RICE CREEK WATERSHED DISTRICT

CONSENT AGENDA

JANUARY 28, 1998

**RICE CREEK
WATERSHED DISTRICT
1998 PERMIT**

**City of Fridley
Rice Creek Bank
Stabilization Project**

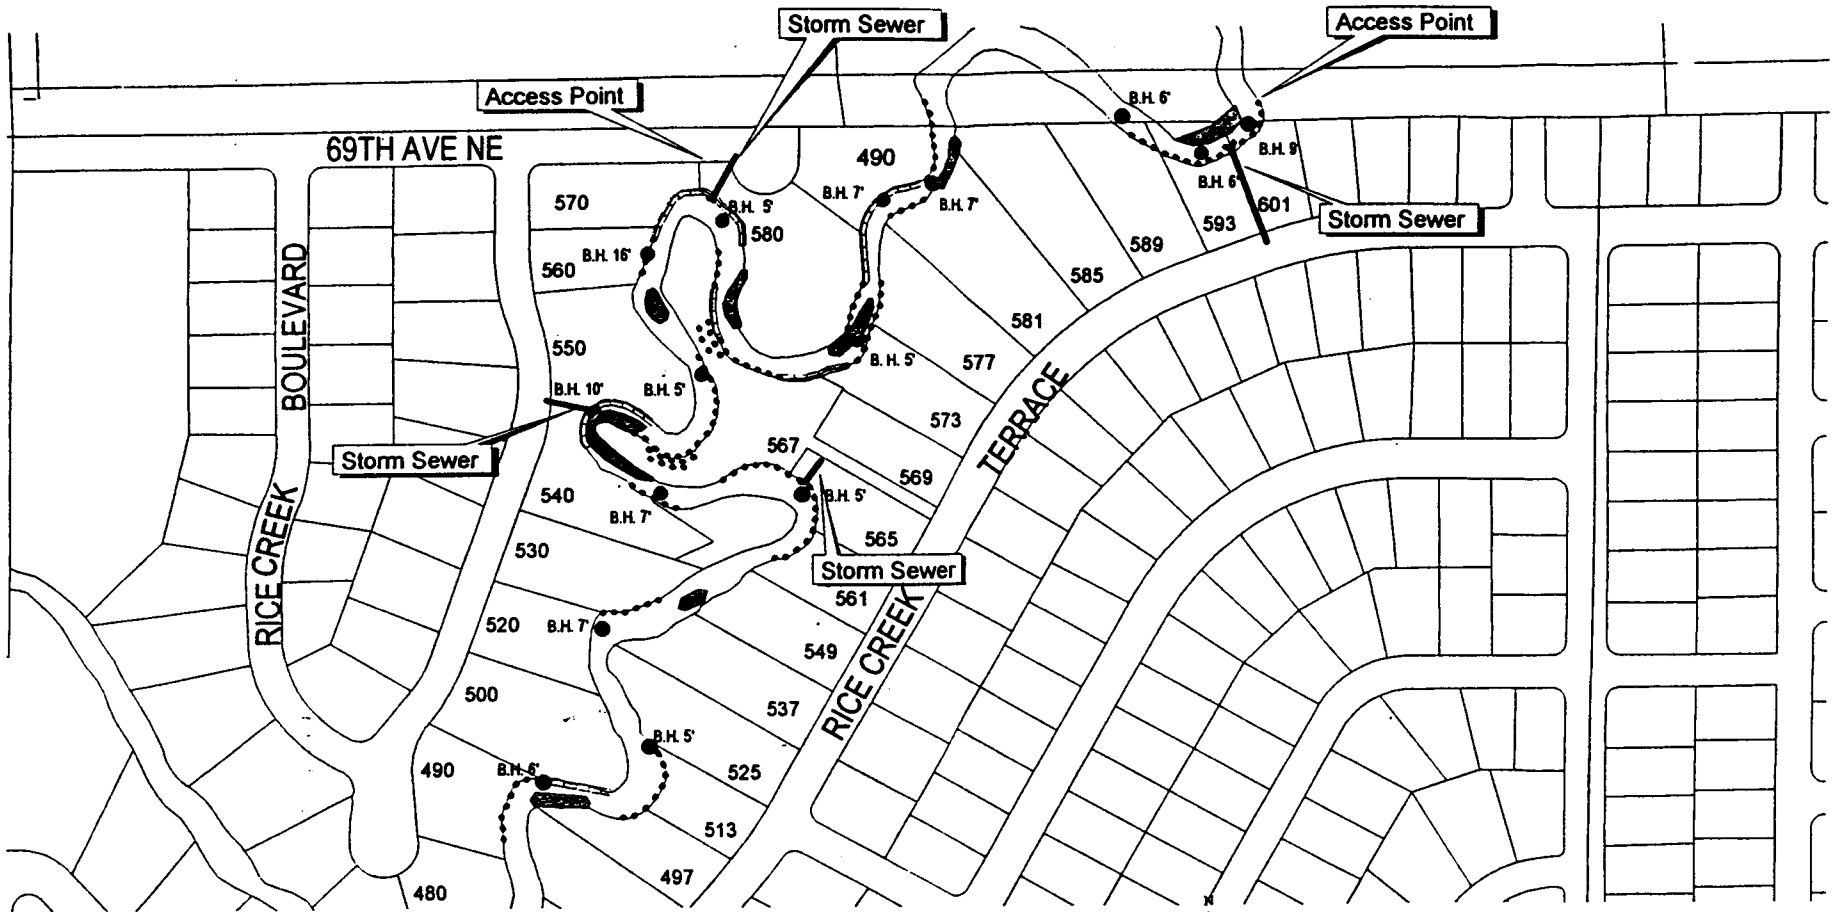
Stipulation: District Inspector to optimize balance of cut and fill to minimize encroachment into the existing channel.

Purpose: Approval of a Shoreland Alteration Plan for bank stabilization of 2,700± feet of Rice Creek.

- Findings:
1. Project involves the bank stabilization of approximately 2,700± feet of Rice Creek. The City of Fridley requested bids for several different materials and designs, including riprap, gabions, MBI block, keystone, or equivalent block.
 2. Multiple coordination meetings between City, DNR, and District have occurred.
 3. Several presentations have been made to the Board regarding overall issues of the project at November and December meetings.
 4. The total project cost estimate is \$265,032 for installation of gabions and riprap. District staff is awaiting a detailed bid tabulation to allow for review of eligible project costs per SBBS program guidelines. ~~Eligible costs total \$265,032, with environmental costs of \$10,000. Total eligible project cost is \$275,032.~~
